# UNITED STATES PATENT AND TRADEMARK OFFICE

APPLICATION NO.	FILING DATE	FIRST NAMED INVENTOR	ATTORNEY DOCKET NO.	CONFIRMATION NO.
10/607,116	06/26/2003	Michael J. Berman	03-0538	3693

<b>Office Action Summary</b>	<b>Application No.</b> 10/607,116	<b>Applicant(s)</b> BERMAN, MICHAEL J.	
	<b>Examiner</b> George Nguyen	<b>Art Unit</b> 3723

**DETAILED ACTION**

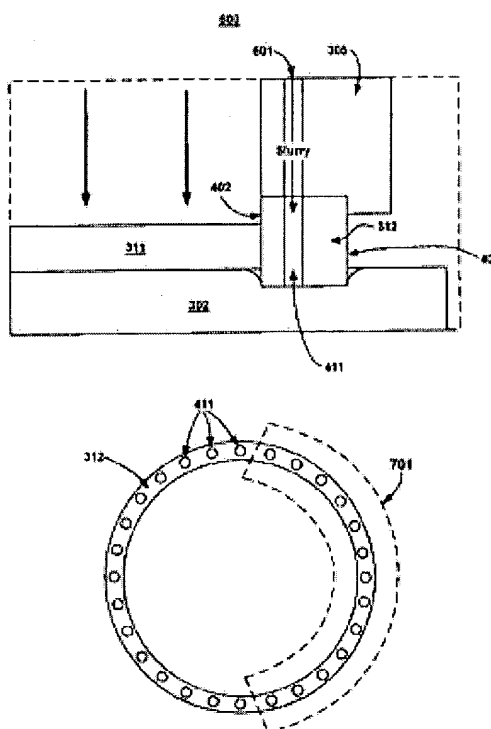
With reference to Figure 6B, col. 7, lines 47-56, Drill discloses the claimed invention except for the at least one channel in communication with the plurality of outlets 411.

With reference now to FIG. 6A and FIG. 6B, FIG. 6A shows a side cut away view of wafer 311 and dispensing ring 312, as wafer 311 and dispensing ring 312 are positioned on top of pad 302. FIG. 6A also shows an area 600, which is shown in greater detail in FIG. 6B. As depicted in FIG. 6B, area 600 shows wafer 311 receiving a downward directed force from the carrier (not shown). Wafer 311 is confined in place on pad 302 by inner radius surface 402. Dispensing ring 312 receives a downward force from arm 306 and is pressed into the resilient surface of pad 302.

In the present embodiment, arm 306 includes a plurality of slurry passages (e.g., passage 601) which align with each of the slurry dispense holes 411. CMP machine 300 pumps slurry through the slurry passages 601, through the slurry dispense holes 411, onto pad 302, and into contact with wafer 311.

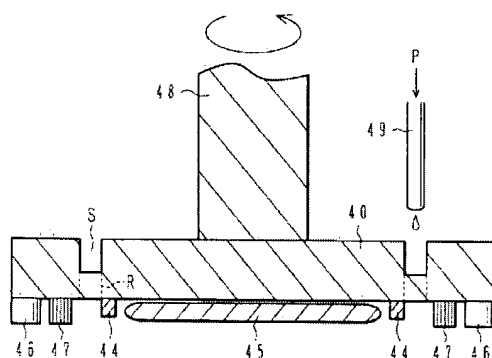
With reference to Figure 22, col. 7, lines 43-59, Tanaka teaches that it is known to have utilized at least one channel S in communication with a number of holes R so that polishing agent P can be supplied therefore from a dispensing nozzle 49 to the wafer 45 via the groove S and holes R. The advantage is to provide a uniform slurry supply to the holes.

The feature of the tool/wafer holder 40 shown in FIG. 23 is that a tool holder unit 40b with a lapping tool 46 is rotated independently from a wafer holder unit 40a with a brush 47. 45 Specifically, the lapping tool 46 is adhered to the bottom of the tool holder unit 40b which is mounted covering the wafer holder 40b, whereas the brush 47 is adhered to the bottom of the wafer holder unit 40a. The tool holder unit 40b is rotated by a rotary shaft 48b disposed coaxially with, and outside of, a rotary shaft 48a for rotating the wafer holder unit 40a. A groove Sa is formed in the tool holder unit 40b, and a groove S corresponding in position to the groove Sa is formed in the wafer holder unit 40a. A number of holes R are formed in the groove S, opening to the bottom surface of the wafer holding tool 40a. Polishing agent P can be supplied therefore from a dispensing nozzle 49 to the wafer 45 via the grooves Sa and S and holes R. 55

Thus, it would have been obvious to one having ordinary skill in the art at the time the invention was made to have modified the wear ring 312 Drill with one common inlet S as taught by Tanaka in order to provide a uniform slurry supply to the holes.
